FIRST AMENDMENT TO SUPPLEMENTAL ENVIRONMENTAL IMPACT REPORT
(RESPONSE TO COMMENTS)

BASEBALL STADIUM IN
THE DIRIDON/ARENA AREA (MODIFIED PROJECT)
SUPPLEMENTAL ENVIRONMENTAL IMPACT REPORT

PROJECT #PP05-214

City of San José

FIGURE III-2

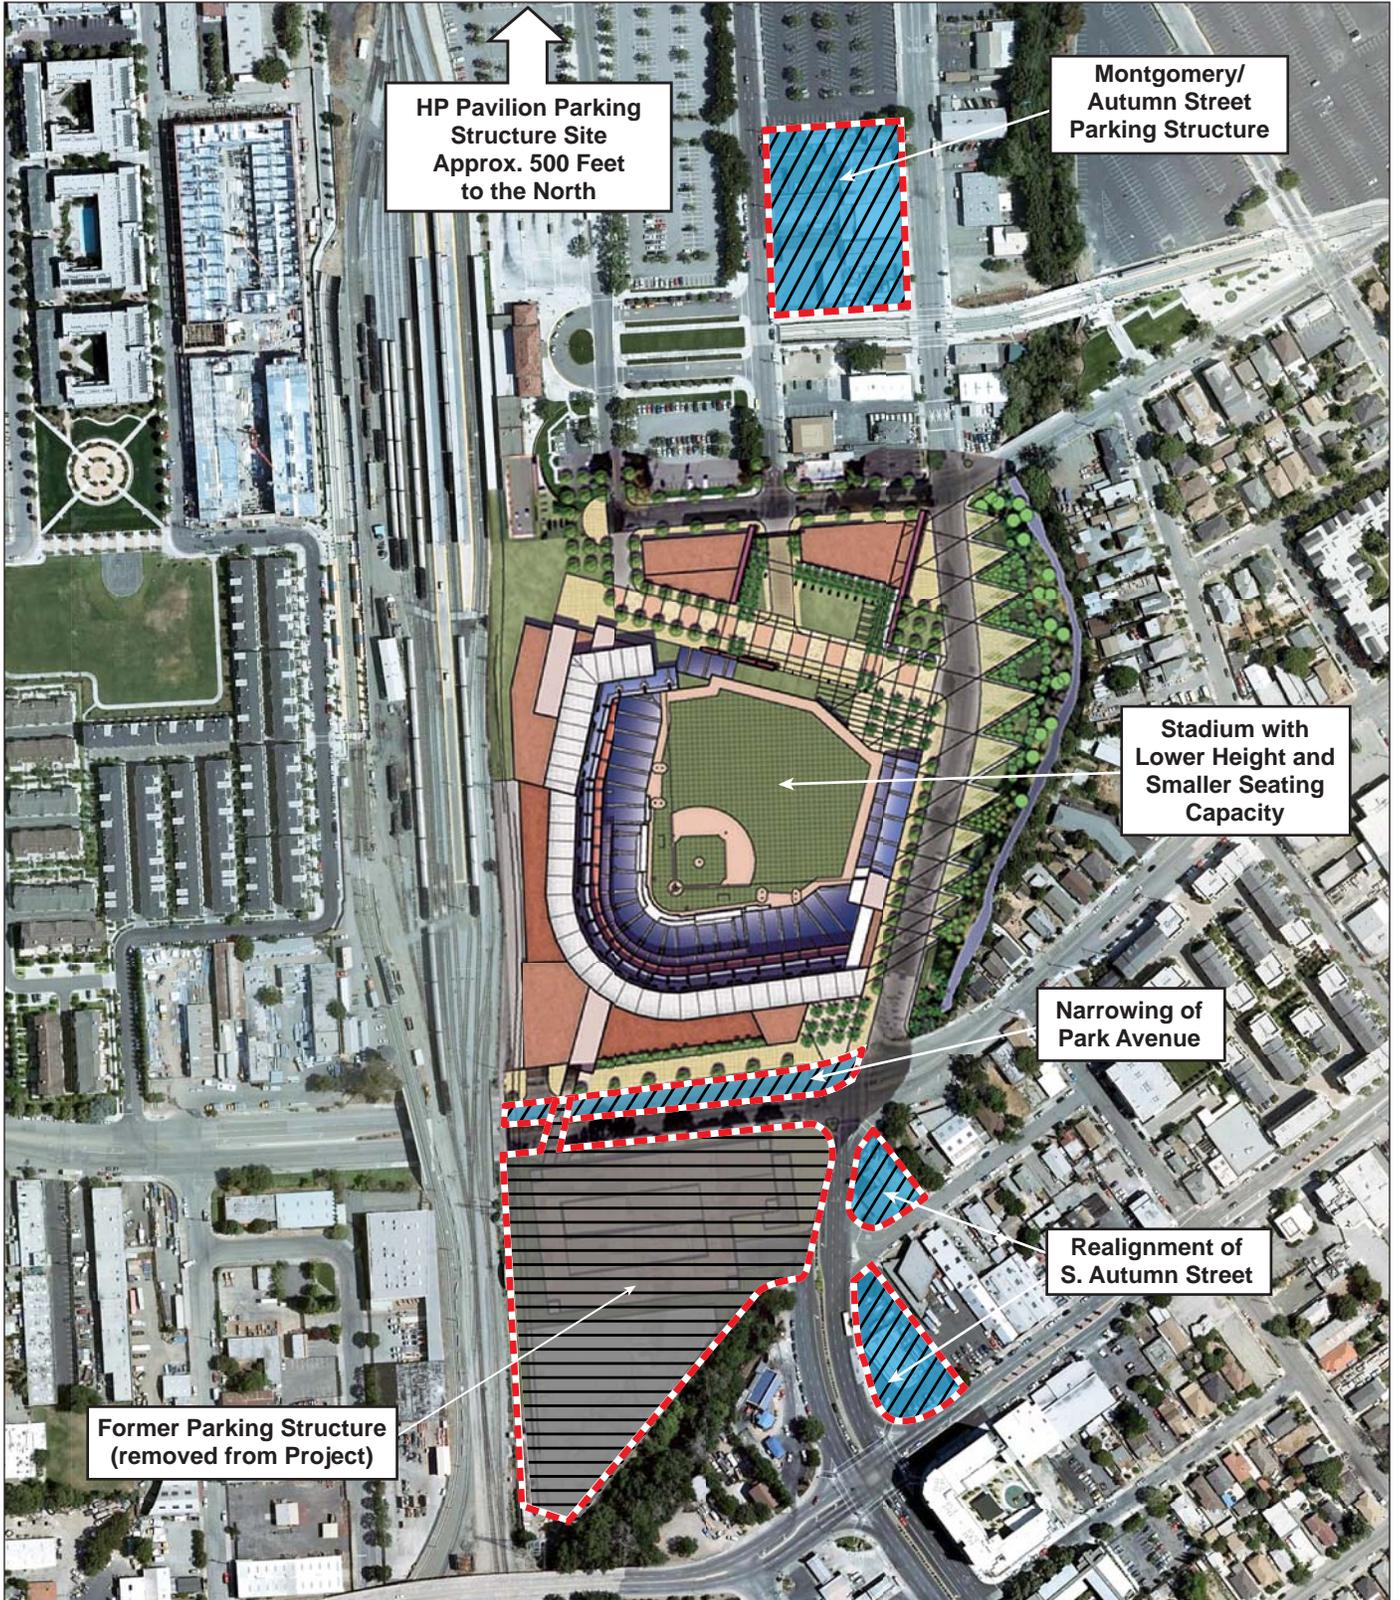
(4) For the record, I would also like to repeat my comment in the Scoping phase of this S-EIR, that the aerial photograph (Fig. III-2) be updated. This figure was copied from the certified EIR and dates back to February 2006. Although the Cahill Park high density housing development and adjacent park are sketched in, this out of date picture may very well give the impression that adjacent land is underutilized or vacant. The same outdated figure was shown at the above referenced Good Neighbor Committee meeting and the Public Meeting at City Hall of March 18, 2010.

- Figure III-2 of the Draft SEIR should be updated to show recent development in the area surrounding the project site. | **6**

D17-4: The underlying aerial photograph for Figure III-2 has been updated and the revised figure is provided following the responses to this comment letter. The updated figure will be included in the Final SEIR.

D18-6: The comment requests that Figure III-2 of the Draft SEIR be updated to show recent development in the area surrounding the project site. The underlying aerial photograph for Figure III-2 has been updated and will be included in the Final SEIR. Please see Response to Comment D17-4.
